**HOOPER CITY
CITY COUNCIL AGENDA
SEPTEMBER 15, 2022 7:00PM
COUNCIL CHAMBERS
5580 W. 4600 S.
Hooper, UT 84315**

Memo

To: Doug & JoAnne Higley and Alan & Valerie Staley
From: Hooper City Staff
CC: Mayor Fowers, Jared Hancock, Tracy Allen, Briant Jacobs
Date: August 8, 2022
Re: Higley Minor Subdivision Review

The Hooper City staff has completed its fifth minor subdivision review of the Higley Subdivision. The purpose of this subdivision is to create two buildable house lots on the west end of parcel 24-005-0030 on the corner of 5600 South and 6300 West. This property is zoned R2. New comments are in **purple**. Completed items have been shaded grey. **Response comments in green.**

OVERALL SITE PLAN FOR
HIGLEY SUBDIVISION
6300 W 5600 S
HOOPER, UT
A Part of the South Half of Section 24
Township 5 North, Range 3 West, S.L.B.M.

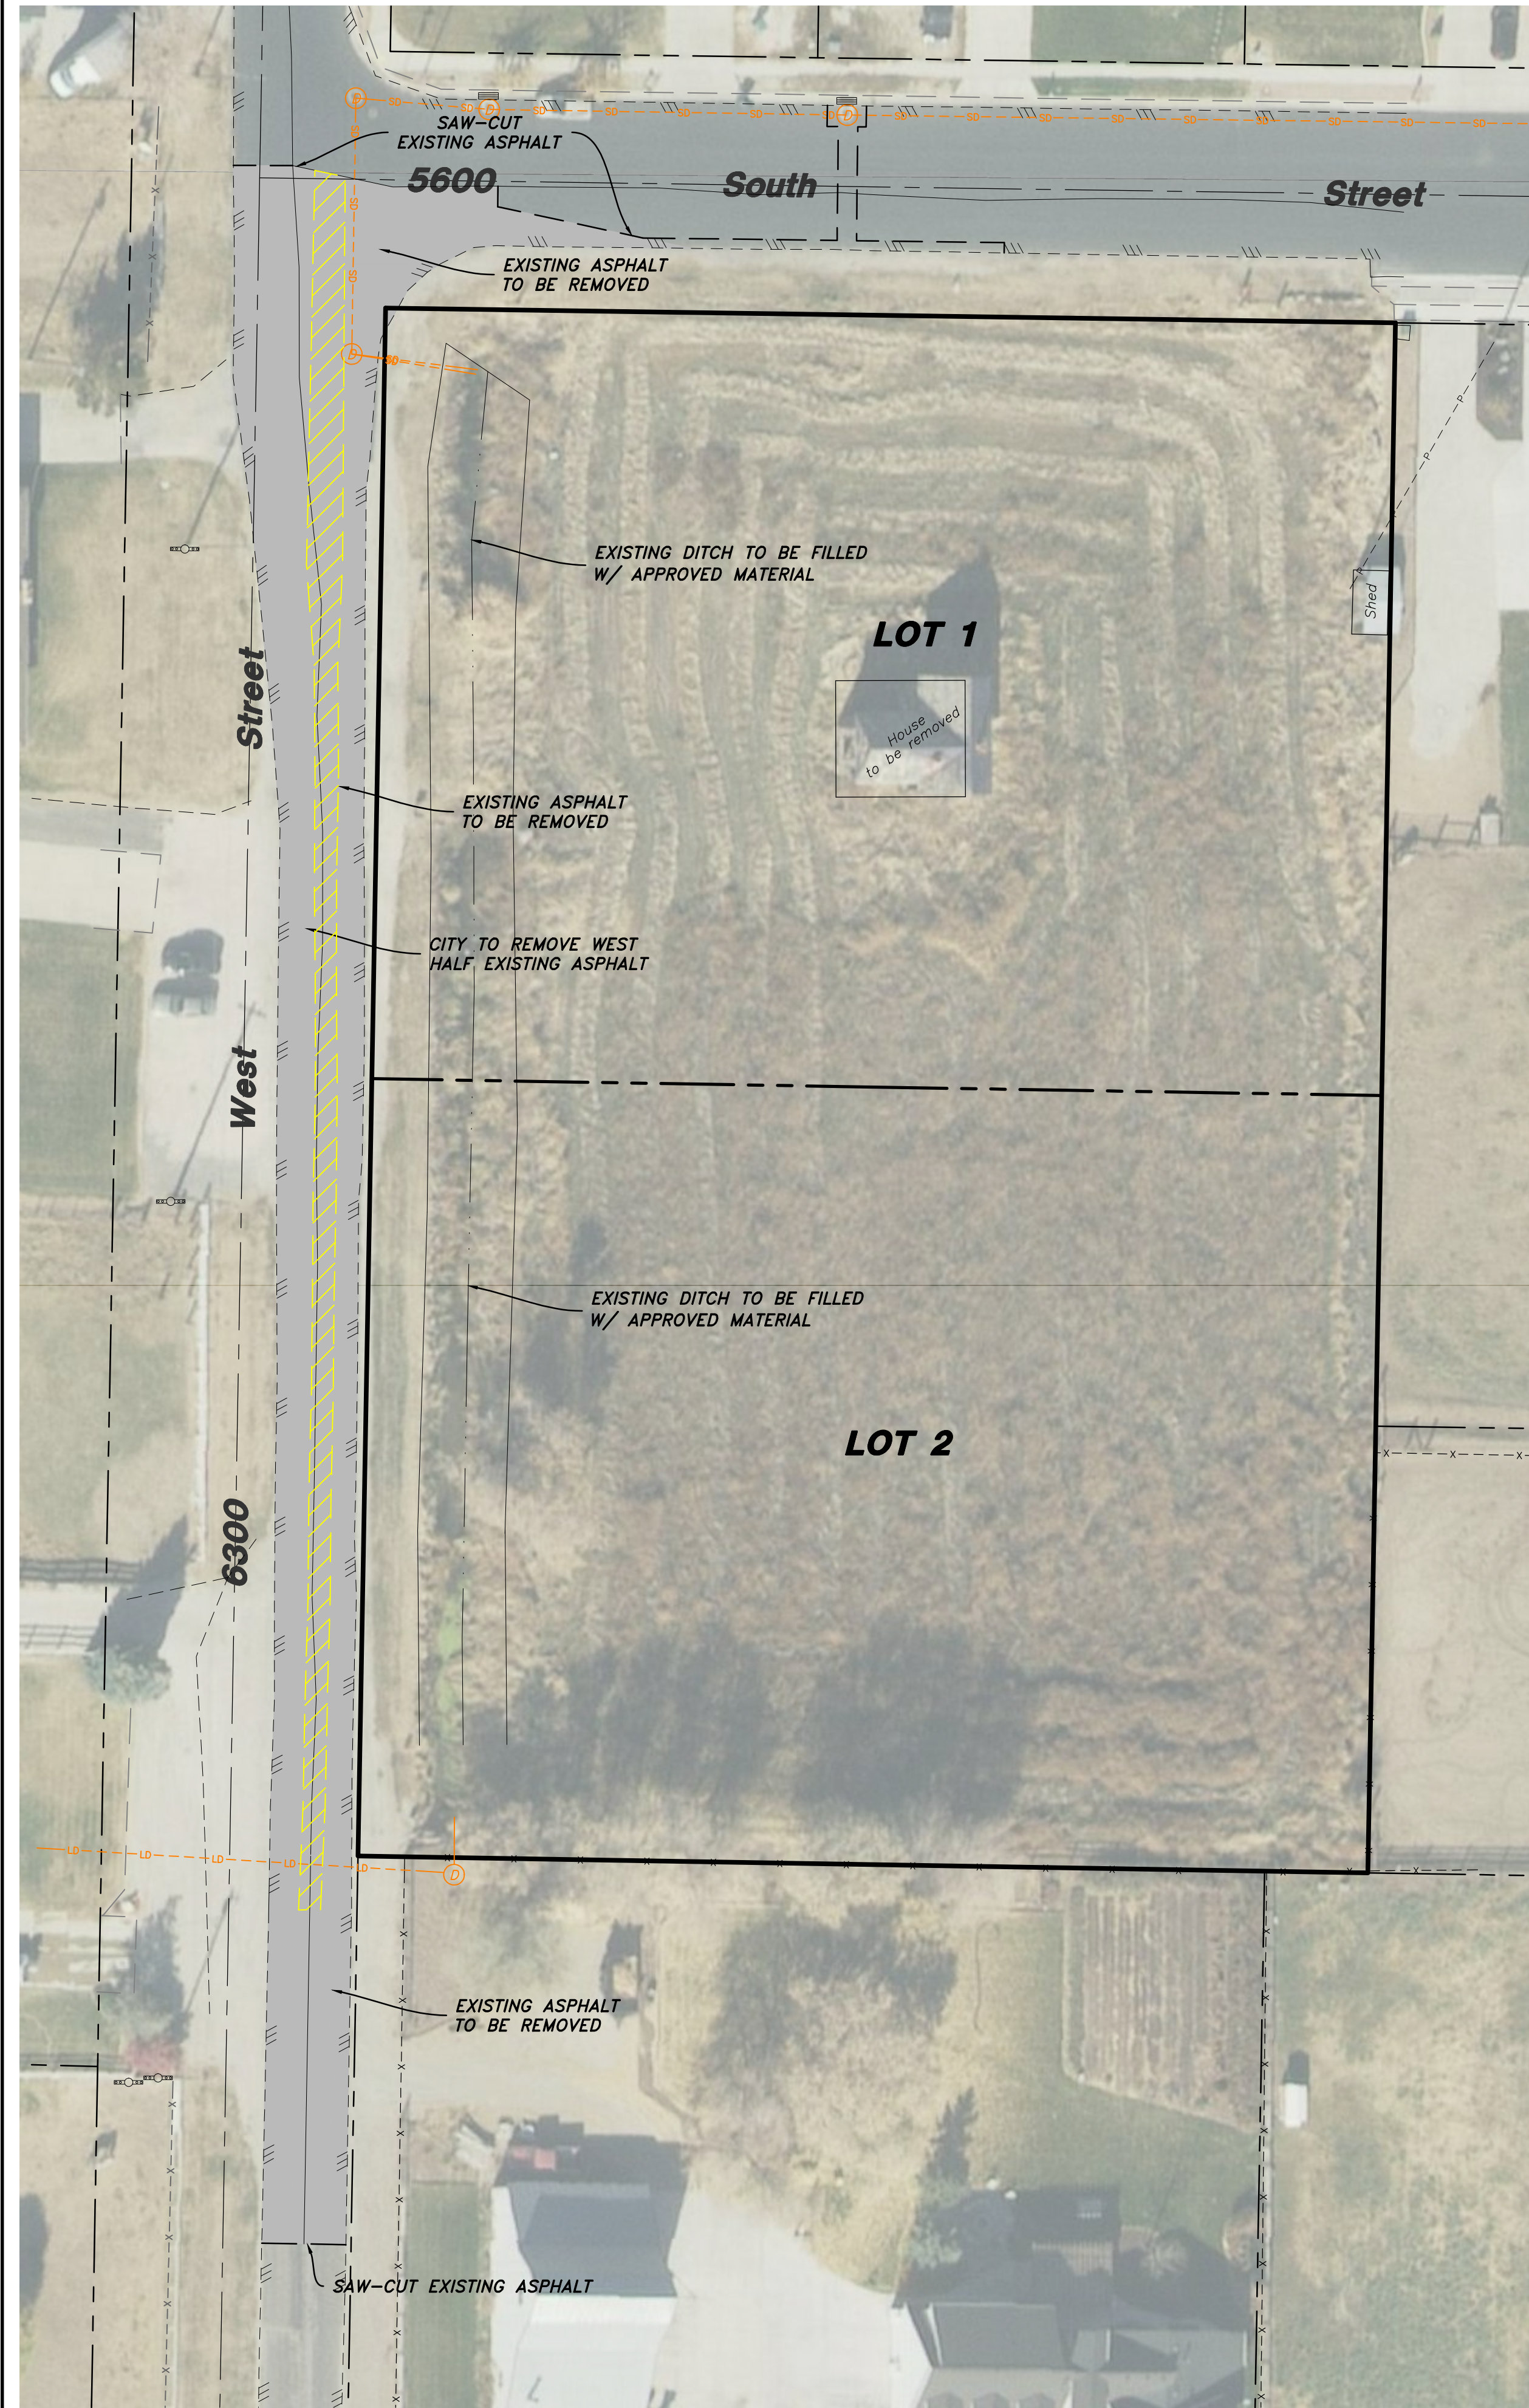
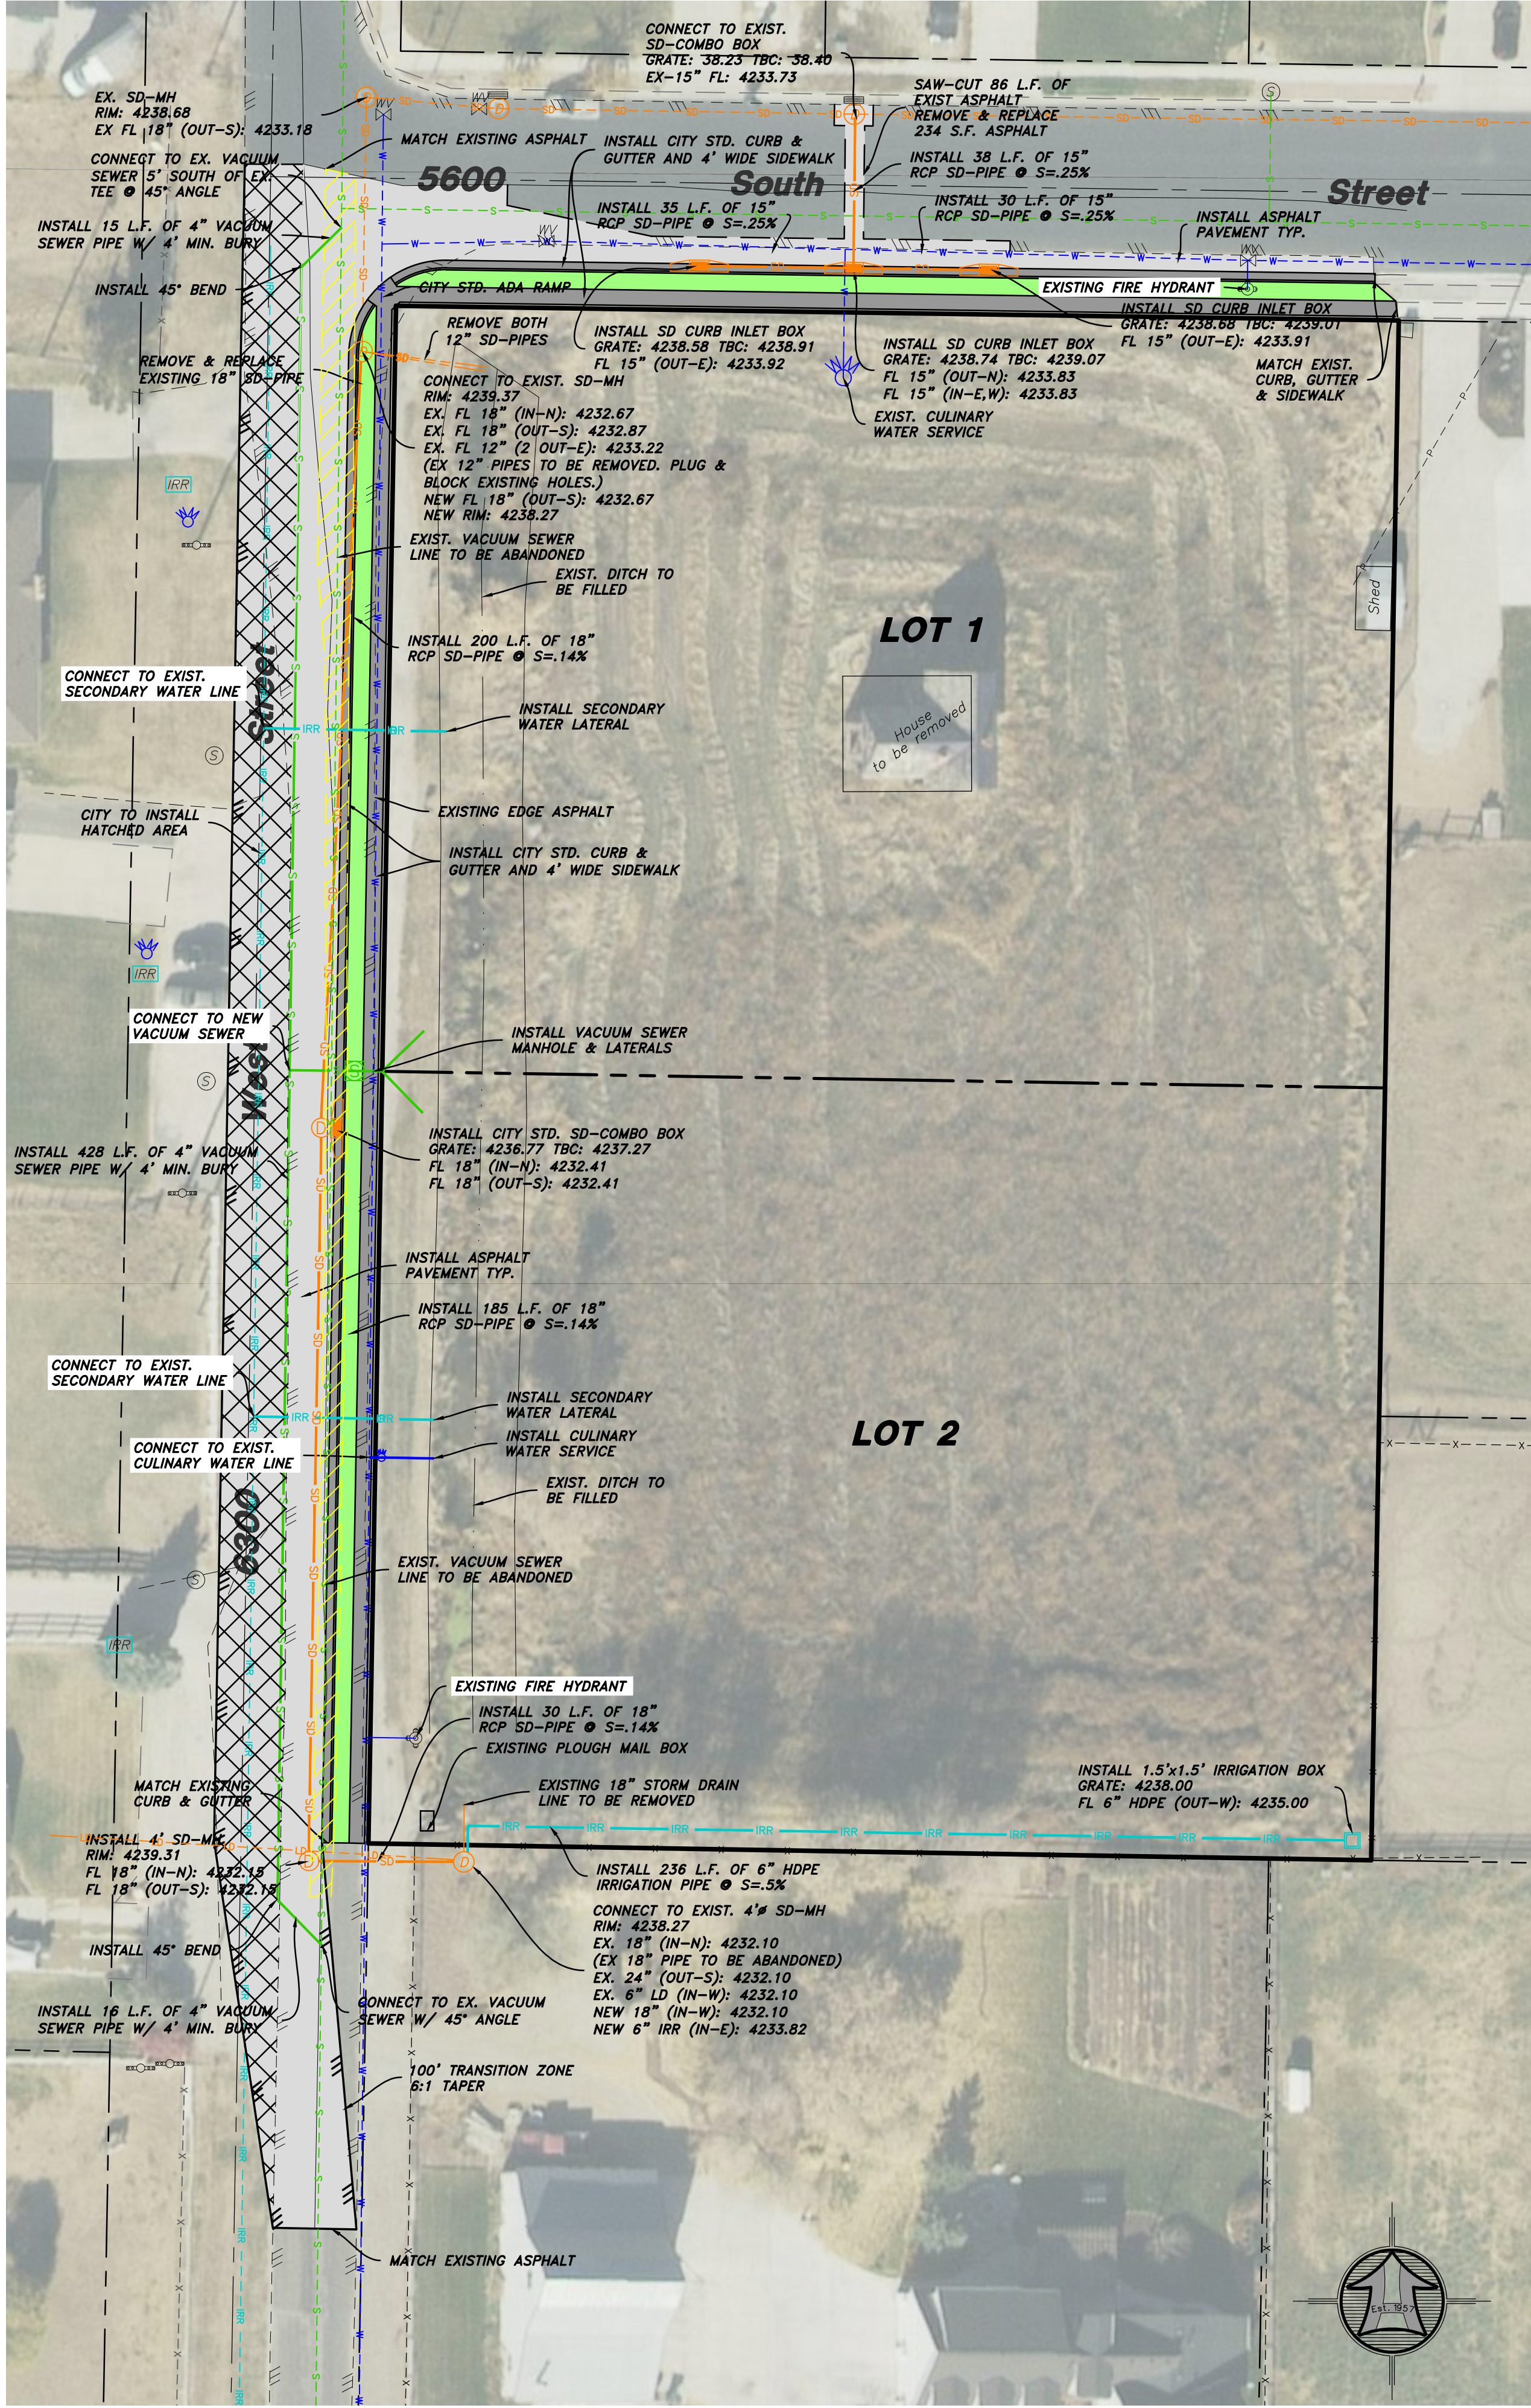
5. The existing ditch to be abandoned on Page 2 will need to be filled in with approved material. *Acknowledged. The fill of the ditch does not need to be structural unless the homeowners want it (like under driveways)."-Briant Jacobs in July 6th email.* **Okay, please add "to be abandoned" to callout of existing ditch on plat. Okay**

6. There is an existing drainage ditch/pipe on the south side of Lot 2 that is used for tailwater from the lots to the east. There will need to be an easement granted for this drainage. The tailwater will need to be piped into the proposed storm drain line in 6300 West and will need to enter by means of a manhole. *The tail water will be piped into the proposed manhole as required. The ditch lies within the proposed Public Utility & Drainage Easement shown on the plat along the south property line. The easement should be labeled "Irrigation/Tailwater Easement" instead of PUE&DE. Per City Code 10-4A-13 Drainage, E. Drainage Ways and Irrigation Ditches, the tailwater ditch will need to be piped along the entire southern lot line of Lot 2. A discussion has been had with the property owners & surrounding landowners. The existing ditch serves none of the surrounding landowners and begins & terminates on the Higley property. As no property requires this ditch it will be filled & abandoned. The City requires that either the ditch needs to be piped or that an agreement from all surrounding property owners stating that they do not use the existing ditch needs to be submitted to the City. Further discussion with JoAnne resulted in her stating that the ditch will be piped. Please add the pipe to the plans and change the callout to be "Irrigation/Tailwater Easement."* **Okay, on the final plat please add a call out to the existing shed identifying it as being "removed or relocated" and remove the "PUE&DE" from the irrigation/tailwater easement. Okay**

7. The connection to the existing storm drain line on the south-west corner of Lot 2 should be altered to reflect the following: **Upon further discussion as to where the existing manhole lies, the connection detail will need to be revised as the tailwater pipe cannot cut across the property line without permission/easement from the neighboring landowner. A suggested detail has been provided.** The tailwater pipe will need to be collected into the proposed storm drain system. Also, in talking to the neighbor on the west side of the street, he confirmed Bret's observation about the PVC pipe plumbed into the existing manhole on the south of the project, that it is his drain line. The proposed connection at ± STA 0+50 is not needed. **Okay**

8. There is an existing land drain line that crosses the street. It is thought to be either a 6 or an 8-inch line. It is next to the plow mailbox on the south-west corner of Lot 2. This line will need to be tied into the proposed storm drain line in 6300 West and will need to enter by means of a manhole. *The land drain is shown connecting to the storm drain system through a manhole as required.* **Okay**
